From: Andrew Pilskalns <ap.castlerock@gmail.com>
Sent: Thursday, September 15, 2016 7:01 PM
To: Simmons, Michelle
Subject: [External_Sender] RE: RE: RE: RE: NRC License Renewal 25-29229-01: Deficiency Letter

From: Simmons, Michelle
Sent: Thursday, August 25, 2016 3:57 PM
To: 'andy@castlerocker.com' <andy@castlerocker.com>
Subject: NRC License Renewal 25-29229-01: Deficiency Letter

Docket No.: 03037201
License No.: 25-29229-01
Control No.: 591140

Materials License No. 25-29229-01

Nuclear Gauge Storage Map

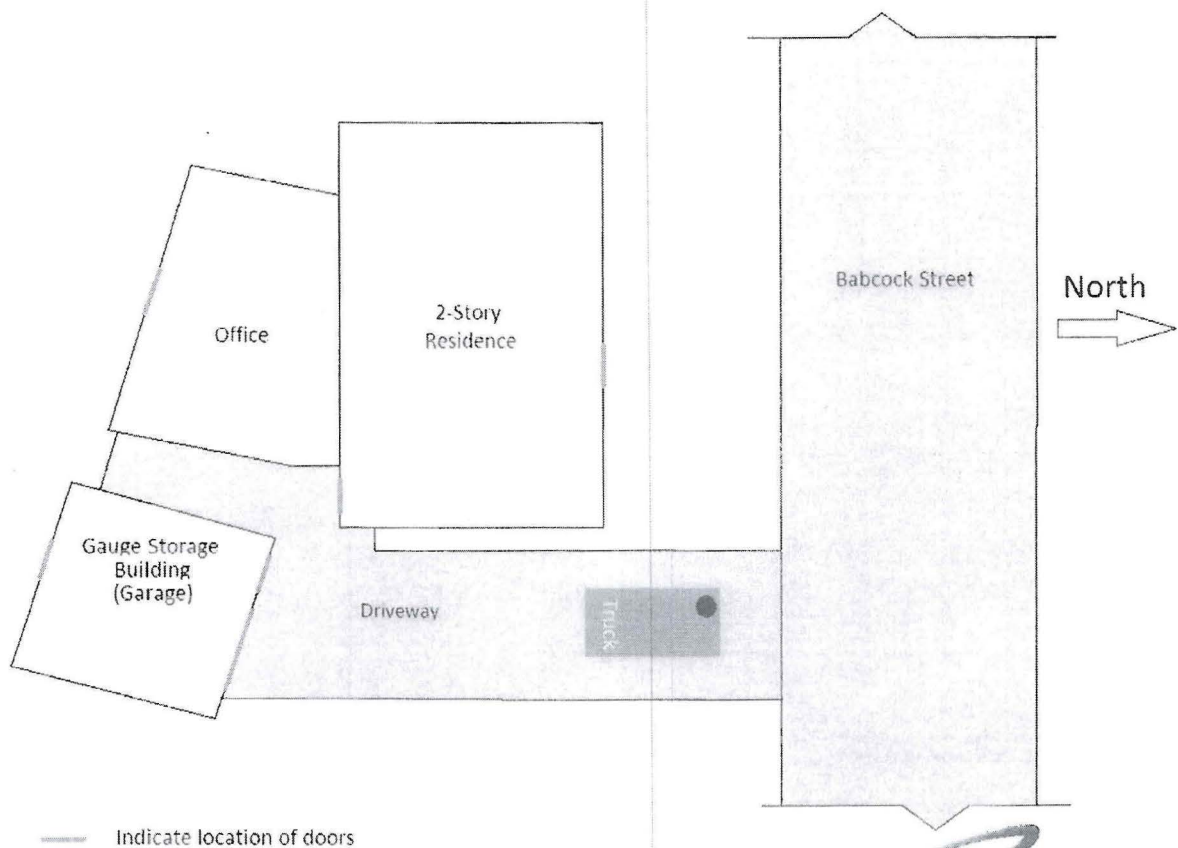
9. FACILITIES AND EQUIPMENT	Provide a facility diagram for each permanent portable gauge storage location. Include on the diagram the use of adjacent areas (including above and below), and information relevant to public dose and security as discussed in Sections 8.10.5, "Public Dose," and 8.10.6, "Operating, Emergency, and Security Procedures," respectively, in NUREG-1556, Vol. 1, Rev. 2, "Consolidated Guidance About Materials Licenses: Program-Specific Guidance About Portable Gauge Licenses"	Submit <input checked="" type="checkbox"/> applicable documentation. <i>SEE Attachment</i>

NOTE: Troxler gauge is locked and secured in company truck.
